Re: St. Lucie Plant Unit 2
Docket No. 50-389
Renewed Facility Operating License No. NPF-16

Response to NRC Instrumentation & Controls Branch Request for Additional
Information Regarding Extended Power Uprate License Amendment Request

Attachment 1
Technical Specifications Table 2.2-1
Revision To Proposed Change Submitted By FPL Letter L-2011-021
Regarding Extended Power Uprate License Amendment Request

TABLE 4.3-1 (Continued)

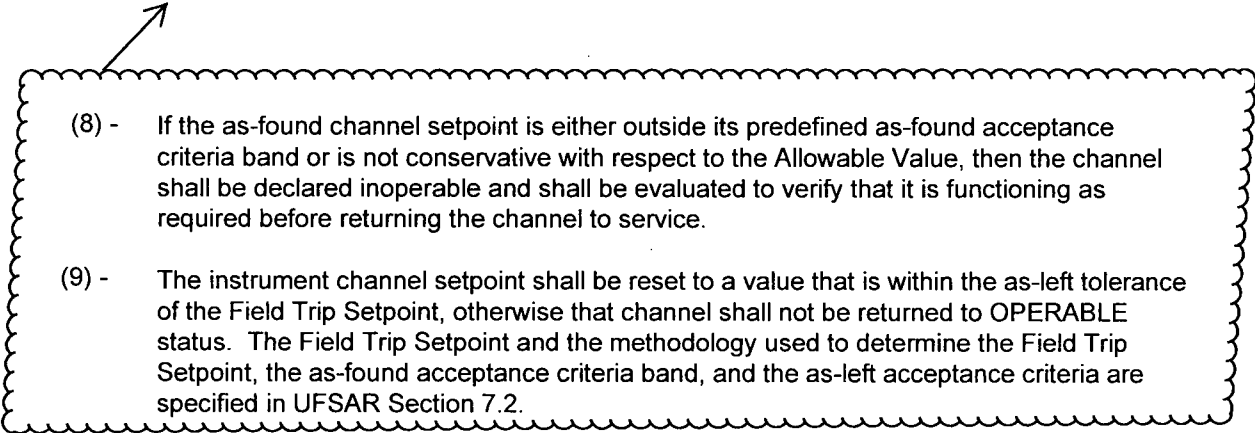
- FUNCTIONAL UNIT 8, Steam Generator Level – Low, CHANNEL FUNCTIONAL TEST will be changed from M to M(8, 9), and
- Table 4.3-1 TABLE NOTATION – New Notes 8 and 9 are added as stated below:

- (8) If the as-found channel setpoint is either outside its predefined as-found acceptance criteria band or is not conservative with respect to the Allowable Value, then the channel shall be declared inoperable and shall be evaluated to verify that it is functioning as required before returning the channel to service.

- (9) The instrument channel setpoint shall be reset to a value that is within the as-left tolerance of the Field Trip Setpoint, otherwise that channel shall not be returned to OPERABLE status. The Field Trip Setpoint and the methodology used to determine the Field Trip Setpoint, the as-found acceptance criteria band, and the as-left acceptance criteria are specified in UFSAR Section 7.2.

Note that Note 9 (previously Note 7) has been modified to change “Trip Setpoint” to “Field Trip Setpoint,” to delete the phrase, “or is not conservative with respect to the Allowable Value,” and to state the specific UFSAR section.

- 
- (8) - If the as-found channel setpoint is either outside its predefined as-found acceptance criteria band or is not conservative with respect to the Allowable Value, then the channel shall be declared inoperable and shall be evaluated to verify that it is functioning as required before returning the channel to service.
 - (9) - The instrument channel setpoint shall be reset to a value that is within the as-left tolerance of the Field Trip Setpoint, otherwise that channel shall not be returned to OPERABLE status. The Field Trip Setpoint and the methodology used to determine the Field Trip Setpoint, the as-found acceptance criteria band, and the as-left acceptance criteria are specified in UFSAR Section 7.2.
